COLLETON CROSSING

ADDENDUM

PUBLIC HEARING CONTINUATION OF THE COLLETON CROSSING AIS CUP;

REVISED STAFF RECOMMENDATION (minor edits/additions)

PROPOSED PHASING PLAN

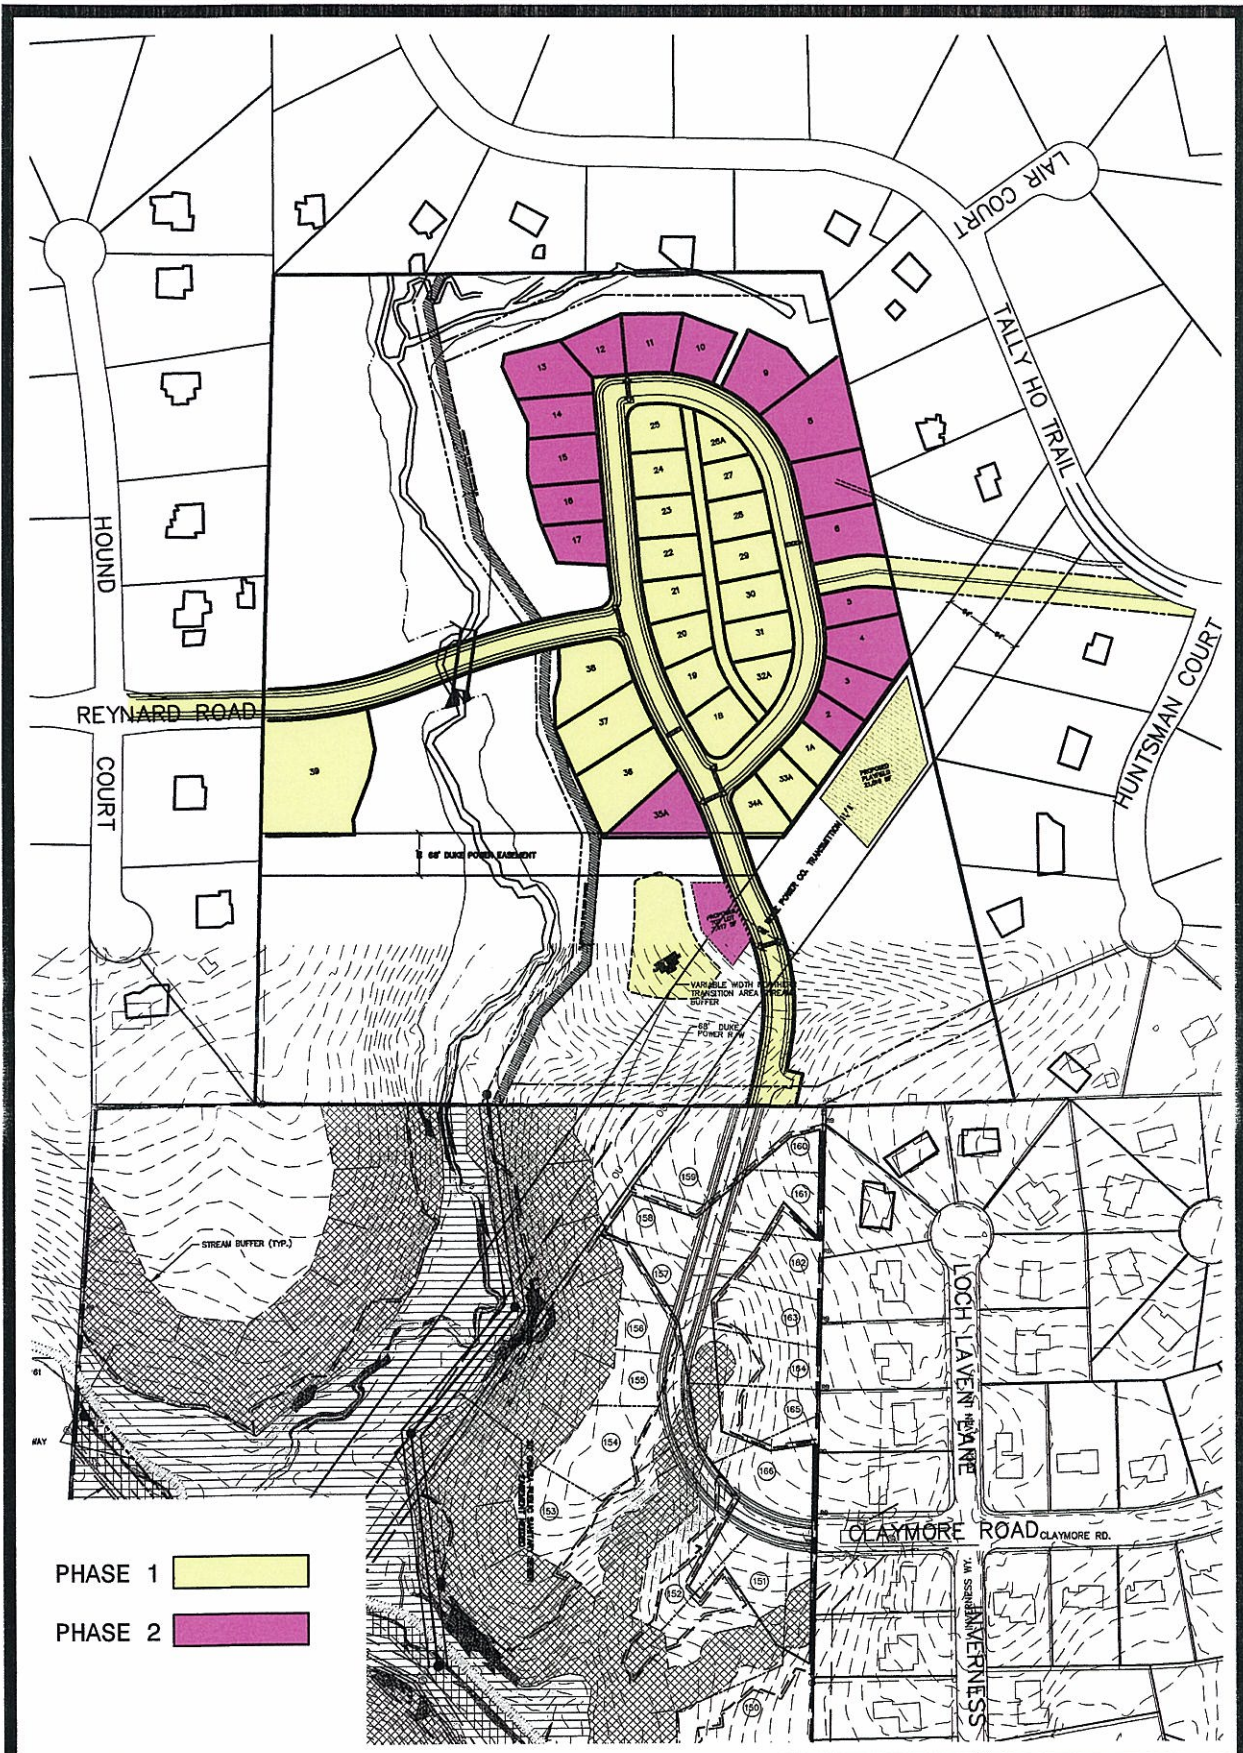
31. That the developer shall phase the project into two (2) phases as shown on the submitted Phasing Plan Exhibit and Building Permit schedule. Phase 1 shall include all infrastructure, and, building permits for 19 market rate lots and 3 affordable lots. Phase 2 shall include 14 market rate lots and 3 affordable lots. The construction of all of the housing units shall be phased over a 2-1/2 year time period, with the release of a limited number of building permits to be made in six (6) month increments as set forth in the Building Permit Schedule. Approval of the final plat for each of the proposed phases will require either the provision-of, or, bonding-for, LUO required recreation, open space and infrastructure components.
